Product / Process Change Notification (PCN)

PCN #: PCN_AsBCMC_20200425

Affected Series: WA-BCMC, 79523141

DETAIL OF CHANGE

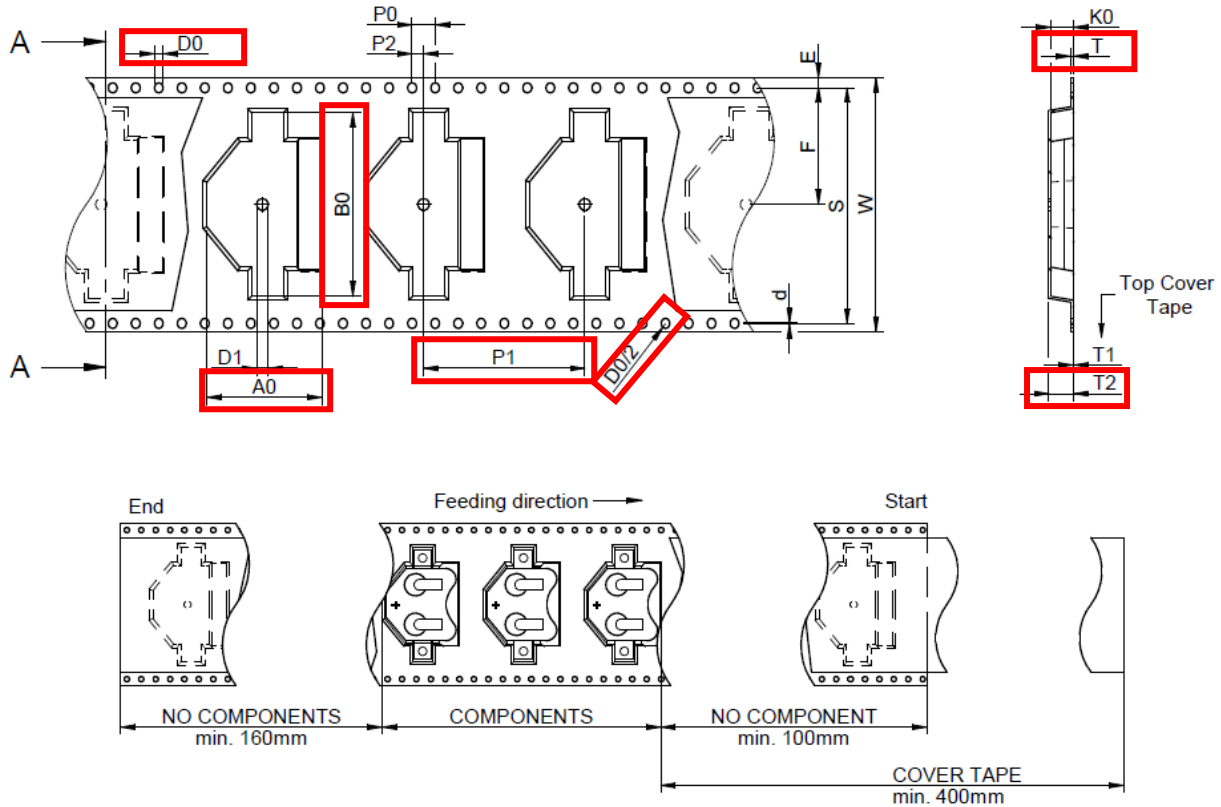
Due to packaging optimizations, Würth Elektronik changes the dimension of the belt. The packaging unit remain the same.

Before Change

A0	B0	W	T	T1	T2	K0	D0/2	D0	D1	E	S	F	P0	P1	P2	Packaging Unit
19,94	31,9	44	0,4	0,1	2	4,2	0,875	1,5	2	1,75	40,4	20,2	4	28	2	500

After Change

A0	B0	W	T	T1	T2	K0	D0/2	D0	D1	E	S	F	P0	P1	P2	Packaging Unit
20,3	31,2	44	0,5	0,1	4,5	4,2	0,775	1,55	2	1,75	40,4	20,2	4	24	2	500
